LAKE PONTCHARTRAIN, LA. AND VICINITY
LAKE PONTCHARTRAIN BARRIER PLAN

DESIGN MEMORANDUM NO.2-GENERAL DESIGN

CITRUS BACK LEVEE

COMMENTS ON DESIGN MEMORANDUM NO. 2 - GENERAL DESIGN, CITRUS BACK LEVEE, LAKE PONTCHARTRAIN, LOUISIANA AND VICINITY, INCLOSED WITH LETTER, LMNED-PP, 21 AUGUST 1967, SUBJECT: LAKE PONTCHARTRAIN, LOUISIANA AND VICINITY, LAKE PONTCHARTRAIN BARRIER PLAN, DESIGN MEMORANDUM NO. 2 - GENERAL, CITRUS BACK LEVEE

PLATE 8

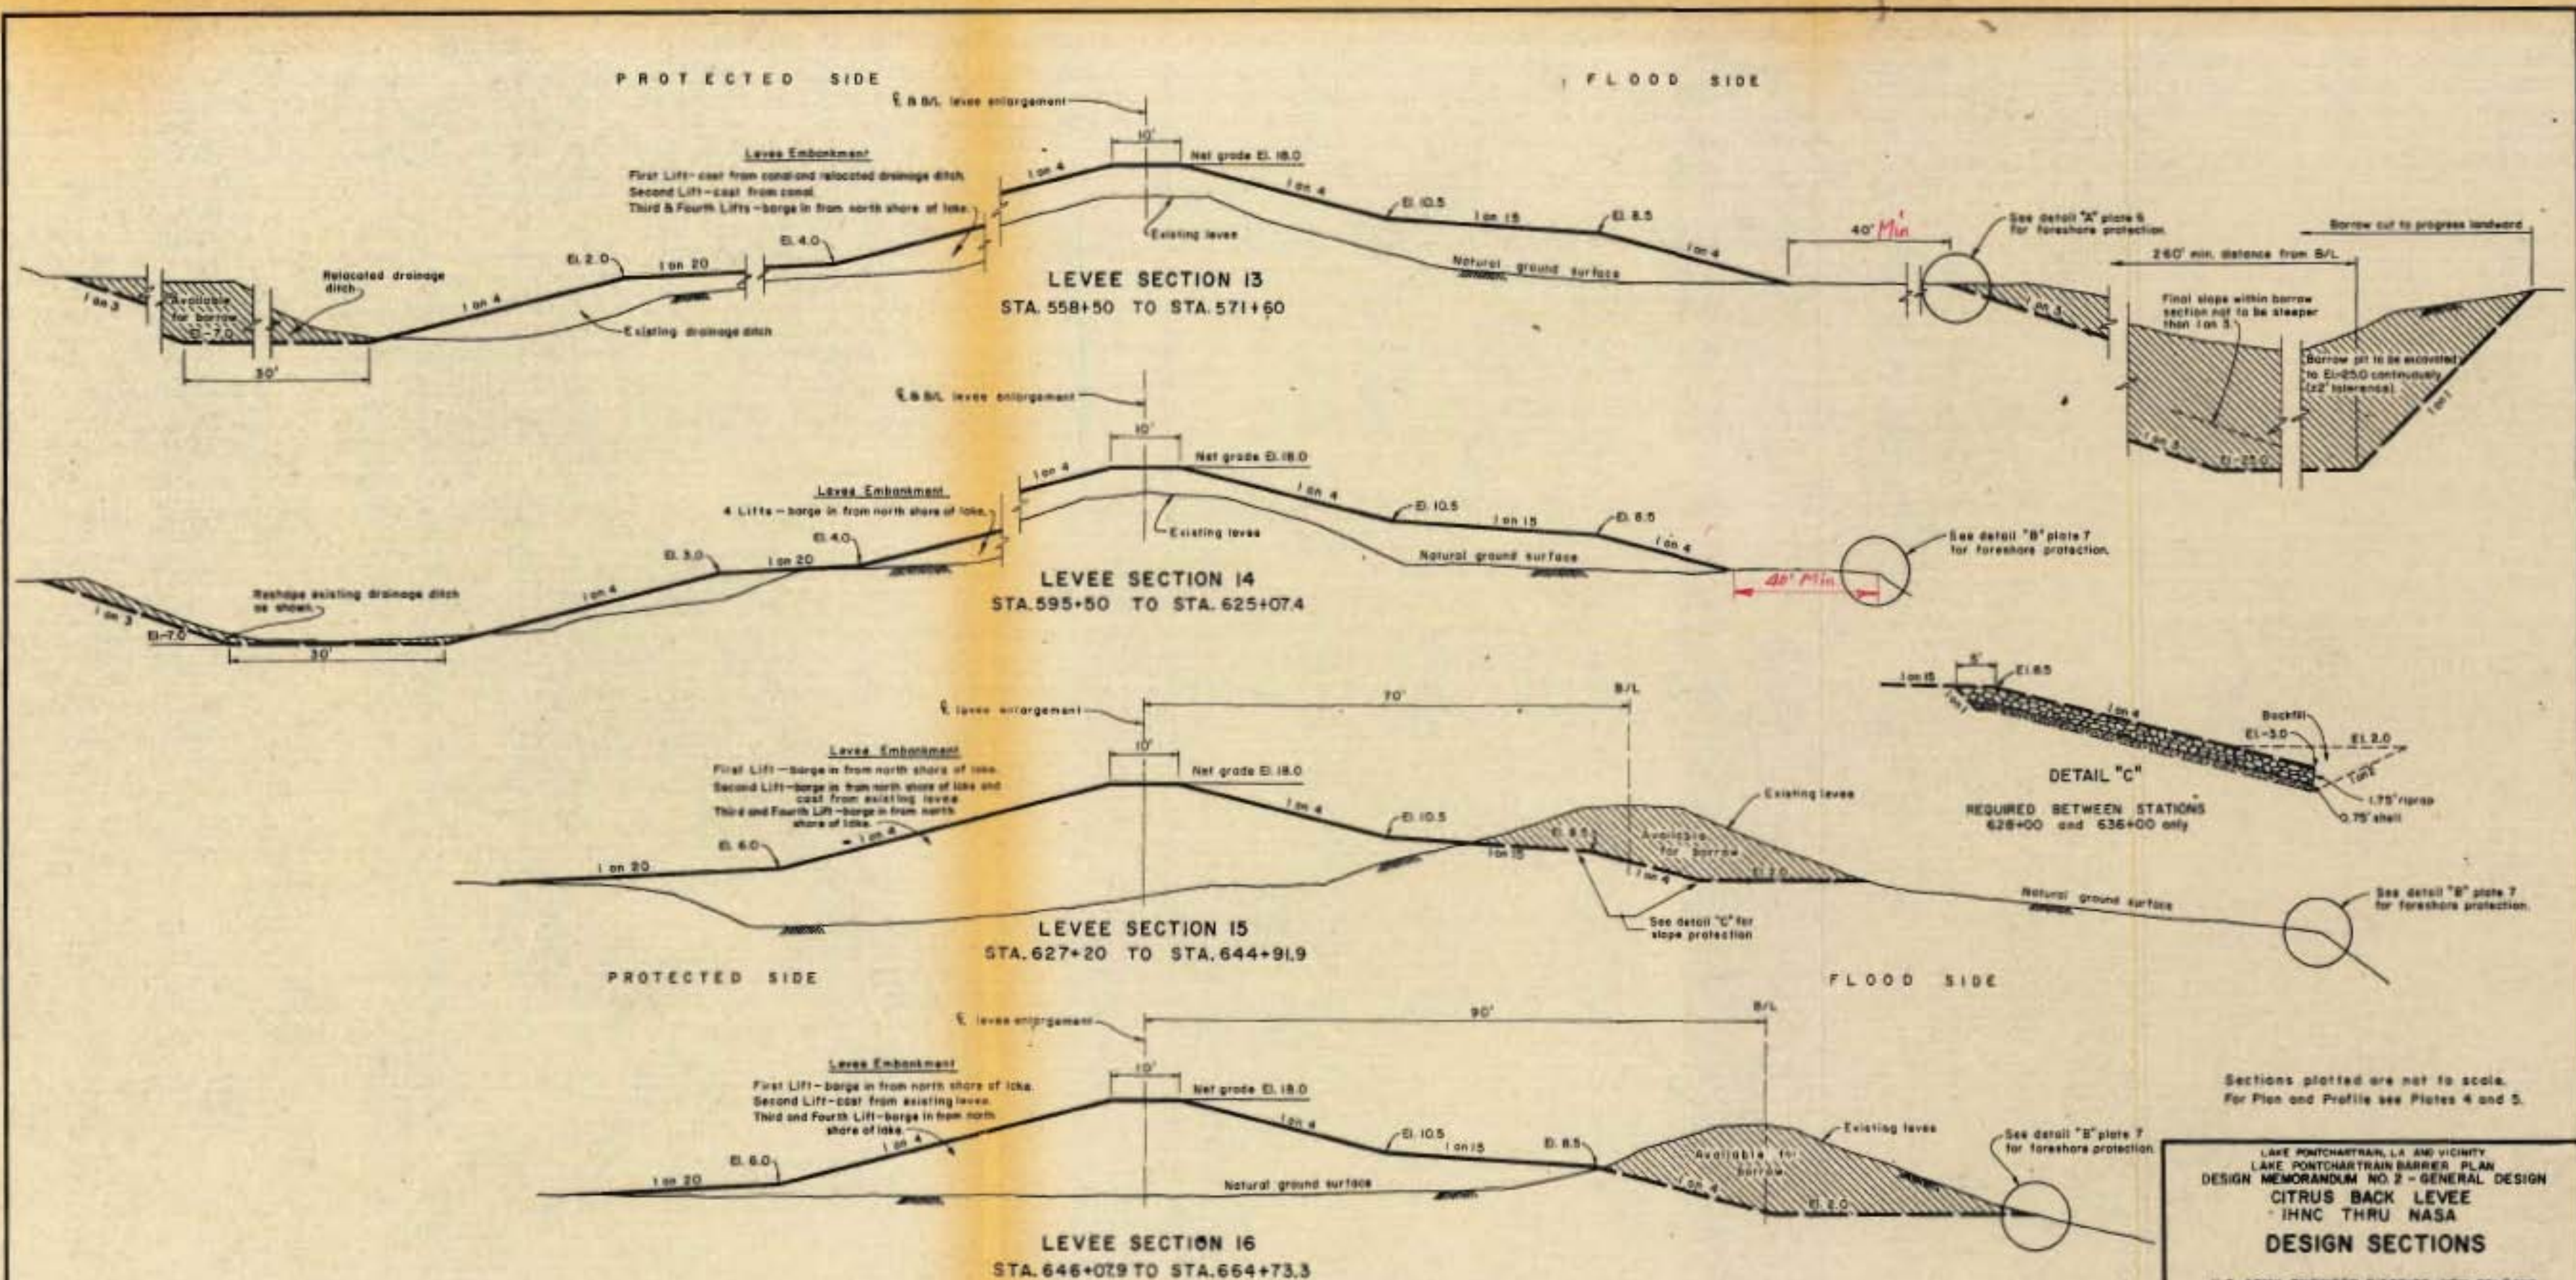
5. Para 56, page 24. Clearly indicate that it is planned to construct the first lift to the grades shown for the final levee on Plates 6 through 9.

LEVEE (Q) STABILITY
(STA. 253+35 to 255+10 & 255+90 to 271+55)

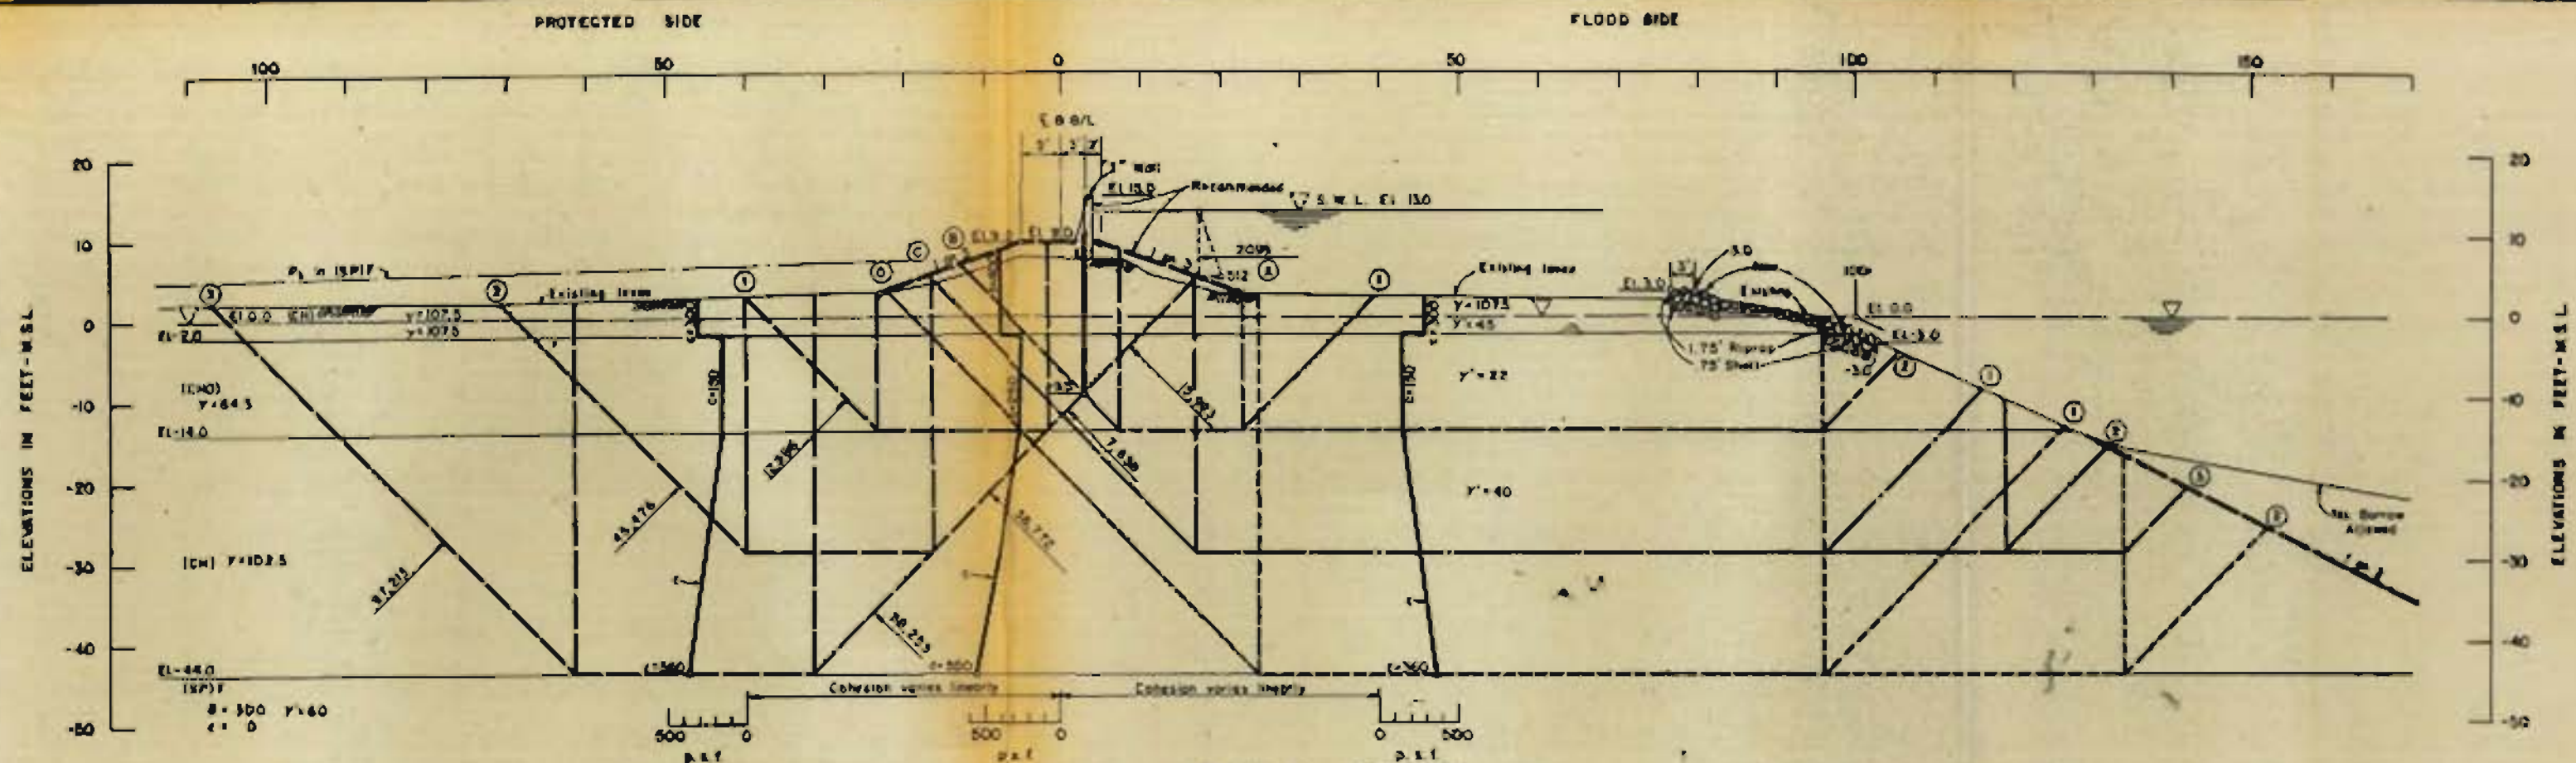
b. The analyses on Plate 42 show a shear strength of $c = 300$ psf from elevation 0 to elevation -10 and elevation -3 to elevation -10. The basis for using this strength instead of $c = 250$ psf as shown on Boring 4-MUT is not apparent. The analyses should be checked using $c = 250$ psf.
